Consented VS Proposed

DESIGN SUMMARY

Stephenson's Way

Planning Permission Nr.: 2018/2316/P

Consented vs Proposed - Roof Level

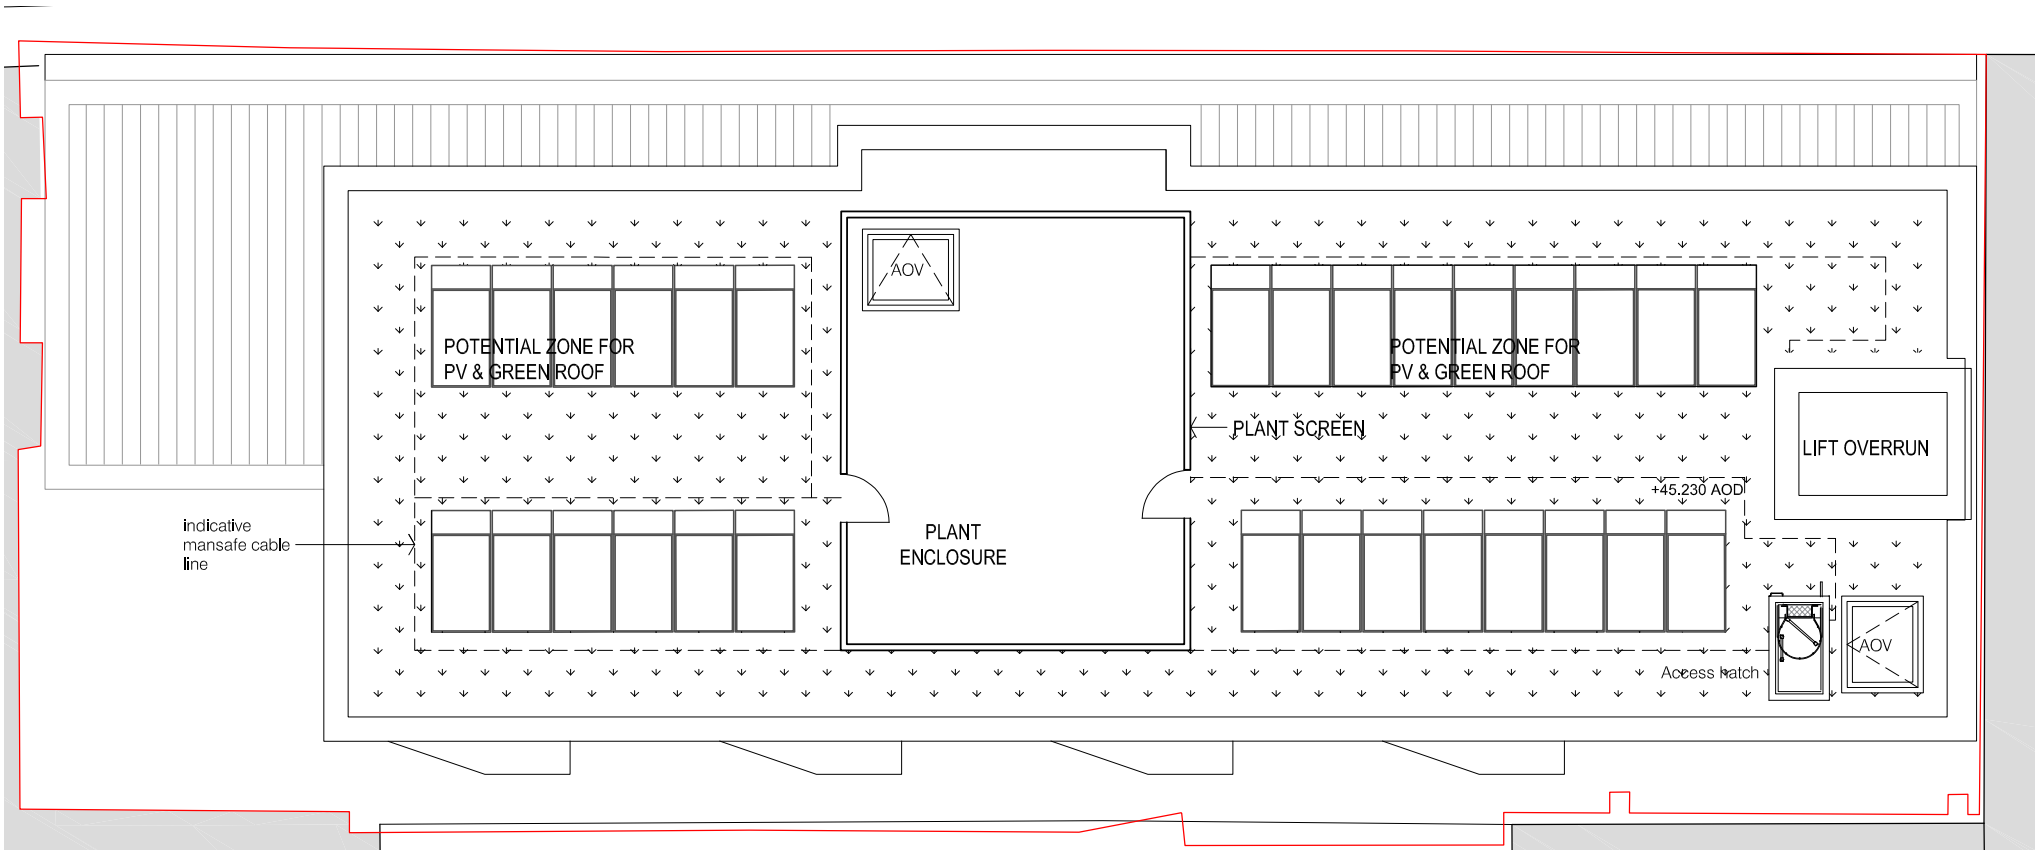
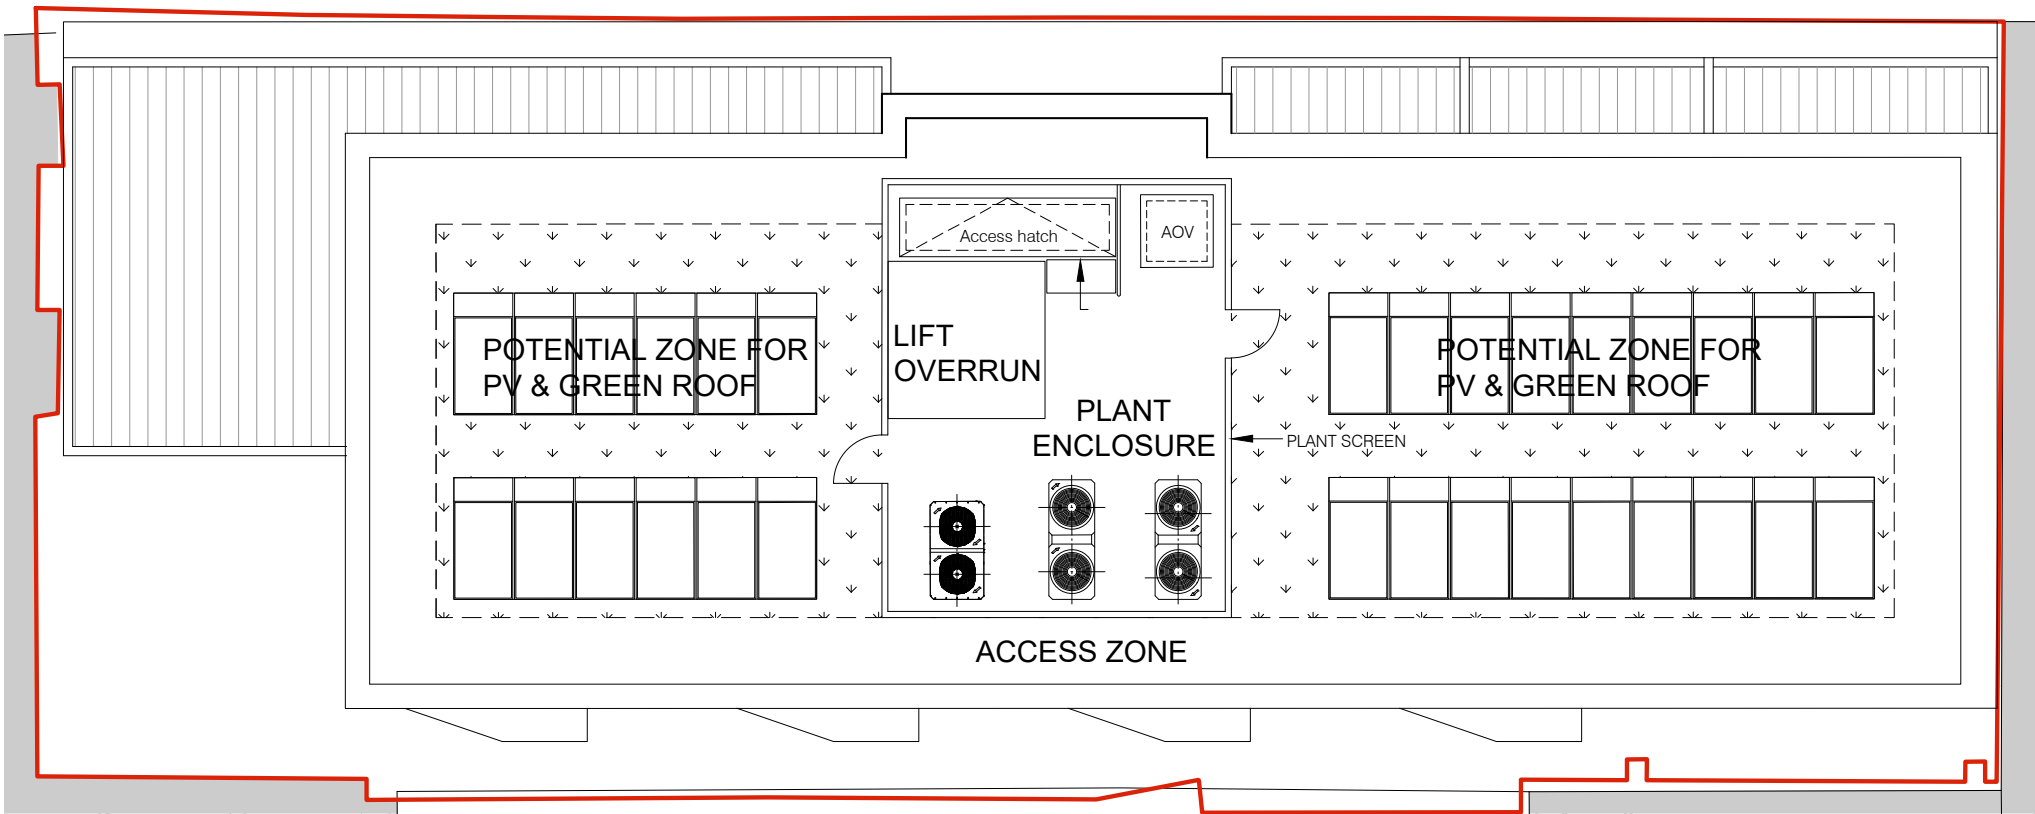
- 1. Secondary stair core added to comply with building safety act and revised building regulations.
- 2. Increased plant areas and UKPN substation added to comply with revised building regulations and increased services requirements.
- 3. Reduction in numbers of studios from 78 to 72 rooms due to secondary stair core and removal of threedio's on the recommendations of the fire consultant as a result of revised building regulations, but still maintaining minimum room sizes required.
- 4. Relocation of platform lift to rear façade to allow for access to the bin store due to new stair location.
- 5. Minor correction to existing ground floor levels due to inaccurate original survey.
- 6. Minor amendments to floor levels due to detailed structural design.

Consented vs Proposed - Front Elevation (Stephensons Way)

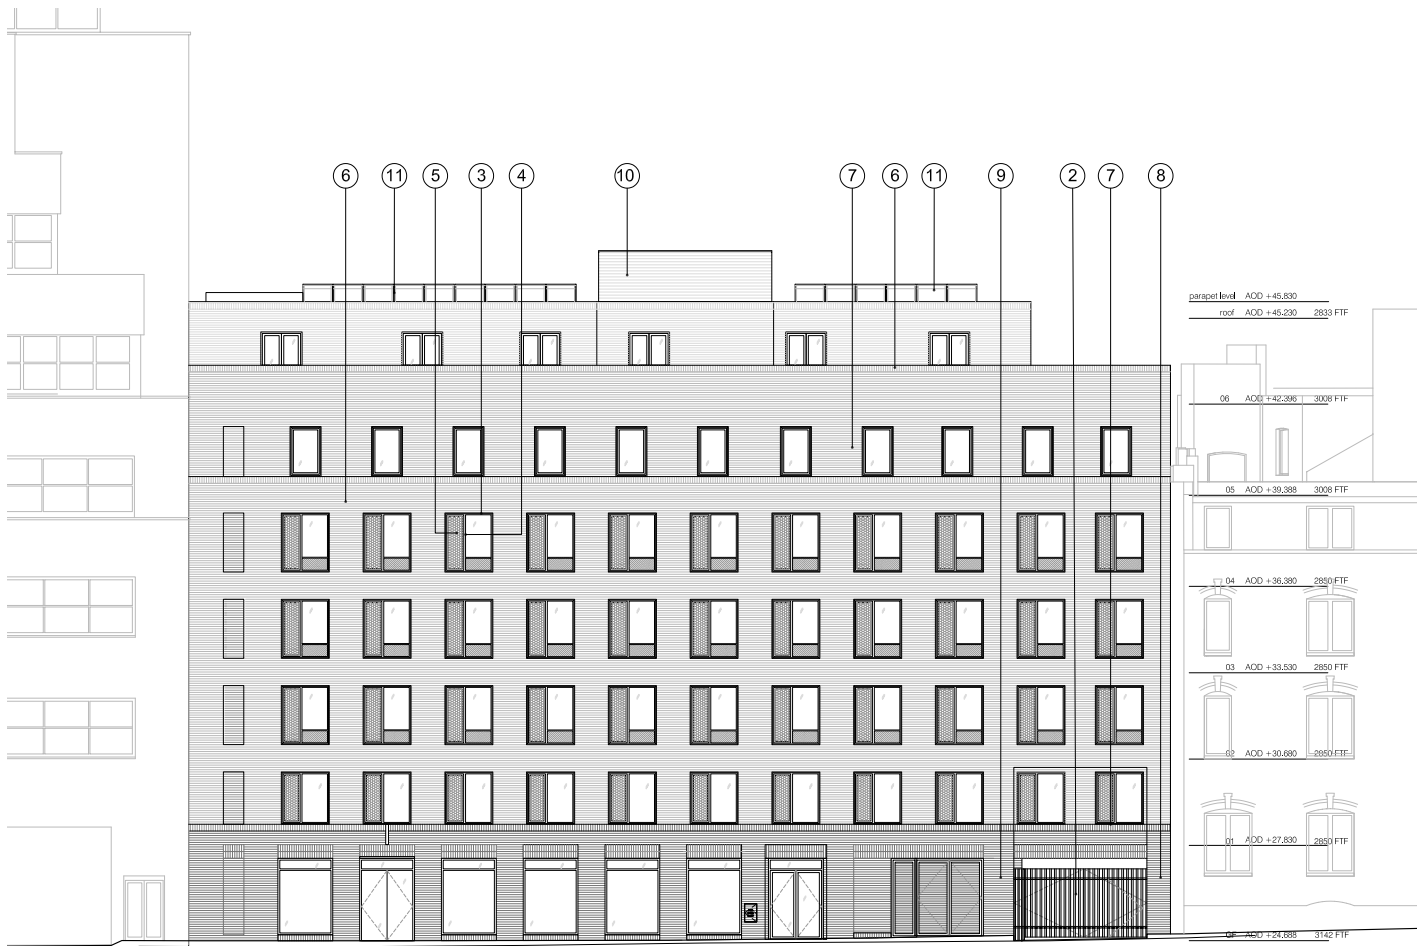
- 1. Secondary stair core added to comply with building safety act and revised building regulations.
- 2. Increased plant areas and UKPN substation added to comply with revised building regulations and increased services requirements.
- 3. Reduction in numbers of studios from 78 to 72 rooms due to secondary stair core and removal of threedio's on the recommendations of the fire consultant as a result of revised building regulations, but still maintaining minimum room sizes required.
- 4. Relocation of platform lift to rear façade to allow for access to the bin store due to new stair location.
- 5. Minor correction to existing ground floor levels due to inaccurate original survey.
- 6. Minor amendments to floor levels due to detailed structural design.

Consented vs Proposed - Rear Elevation

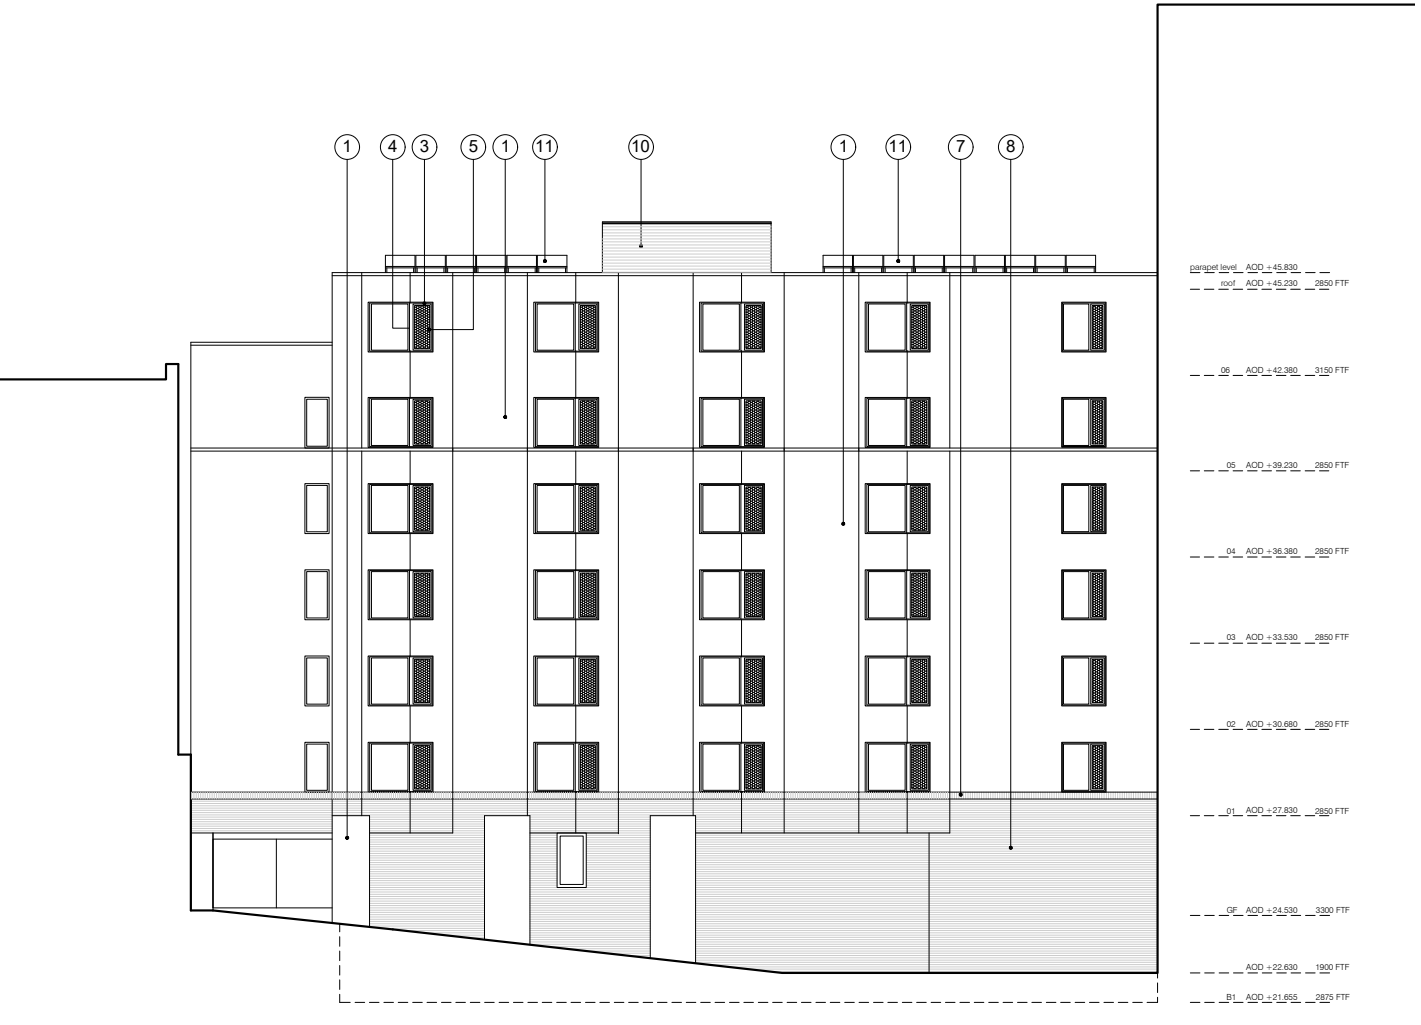
- 1. Secondary stair core added to comply with building safety act and revised building regulations.
- 2. Increased plant areas and UKPN substation added to comply with revised building regulations and increased services requirements.
- 3. Reduction in numbers of studios from 78 to 72 rooms due to secondary stair core and removal of threedio's on the recommendations of the fire consultant as a result of revised building regulations, but still maintaining minimum room sizes required.
- 4. Relocation of platform lift to rear façade to allow for access to the bin store due to new stair location.
- 5. Minor correction to existing ground floor levels due to inaccurate original survey.
- 6. Minor amendments to floor levels due to detailed structural design.

Consented vs Proposed - Section AA

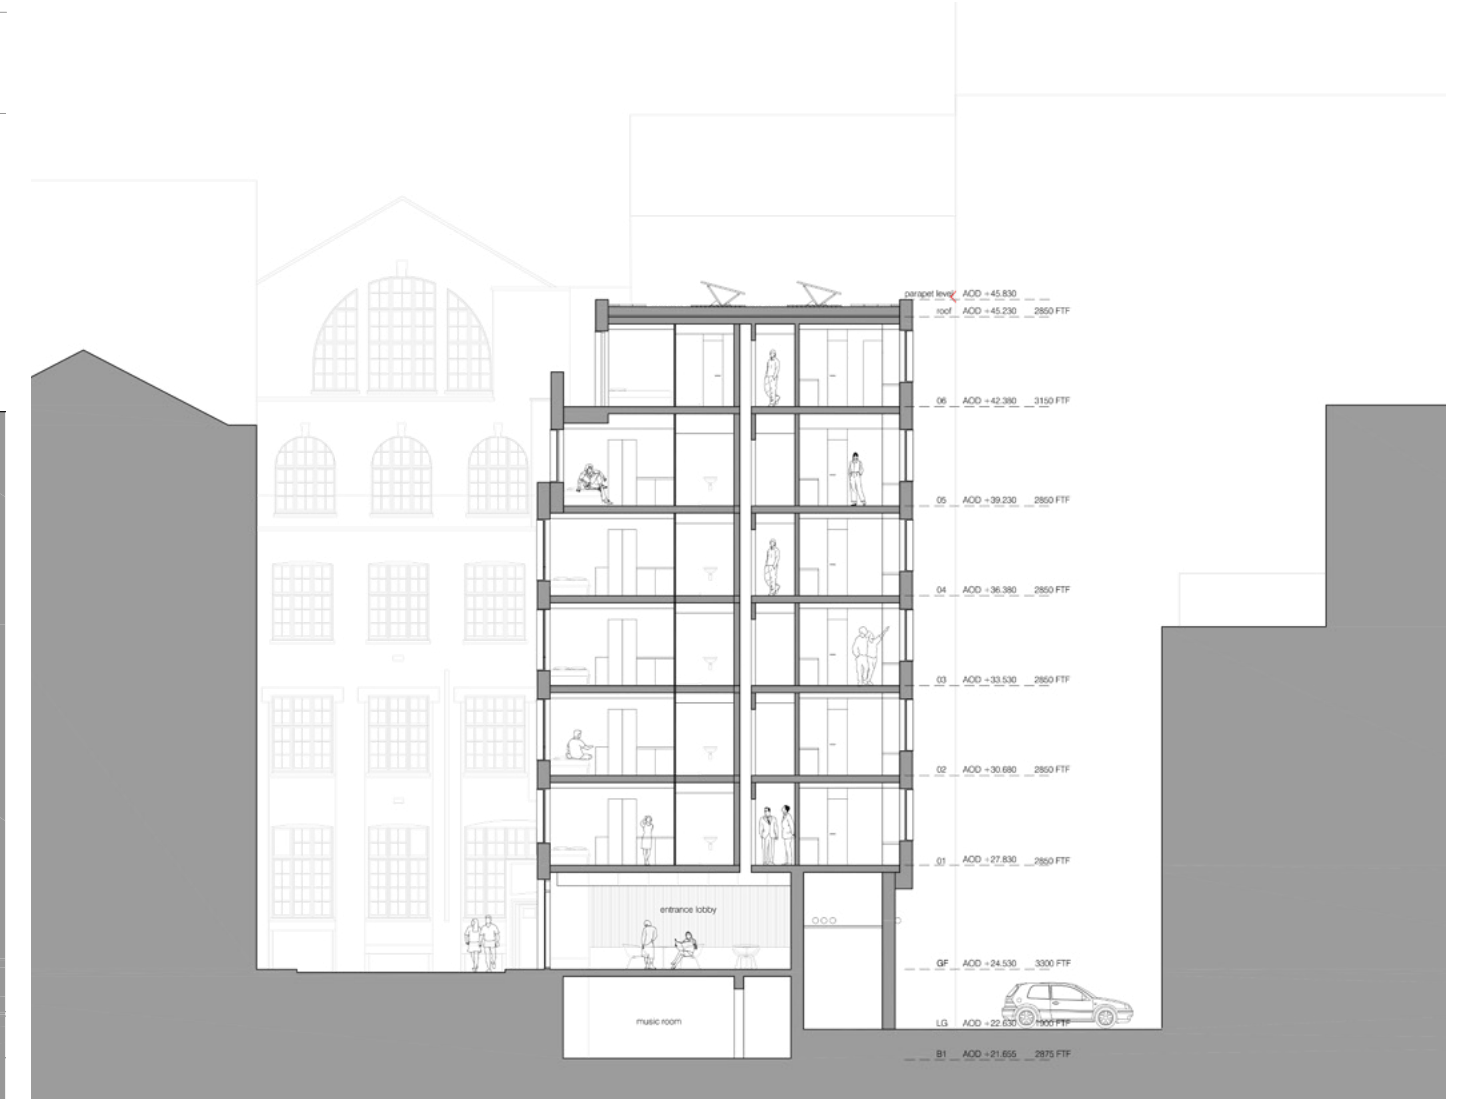
1. Secondary stair core added to comply with building safety act and revised building regulations.
2. Increased plant areas and UKPN substation added to comply with revised building regulations and increased services requirements.
3. Reduction in numbers of studios from 78 to 72 rooms due to secondary stair core and removal of threedio's on the recommendations of the fire consultant as a result of revised building regulations, but still maintaining minimum room sizes required.
4. Relocation of platform lift to rear façade to allow for access to the bin store due to new stair location.
5. Minor correction to existing ground floor levels due to inaccurate original survey.
6. Minor amendments to floor levels due to detailed structural design.

Consented vs Proposed - Section BB

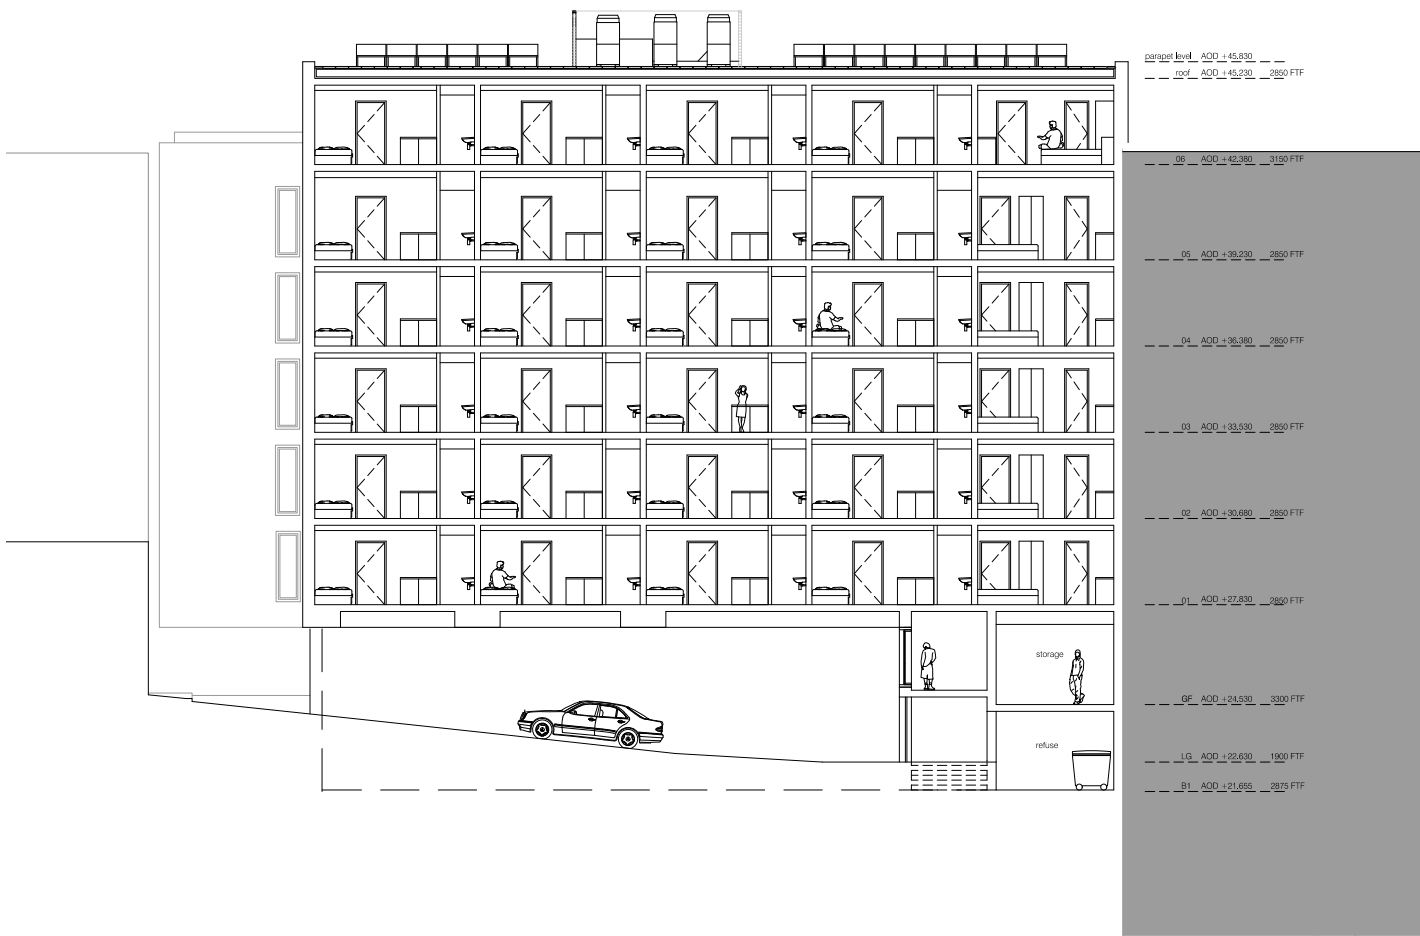
- 1. Secondary stair core added to comply with building safety act and revised building regulations.
- 2. Increased plant areas and UKPN substation added to comply with revised building regulations and increased services requirements.
- 3. Reduction in numbers of studios from 78 to 72 rooms due to secondary stair core and removal of threedio's on the recommendations of the fire consultant as a result of revised building regulations, but still maintaining minimum room sizes required.
- 4. Relocation of platform lift to rear façade to allow for access to the bin store due to new stair location.
- 5. Minor correction to existing ground floor levels due to inaccurate original survey.
- 6. Minor amendments to floor levels due to detailed structural design.
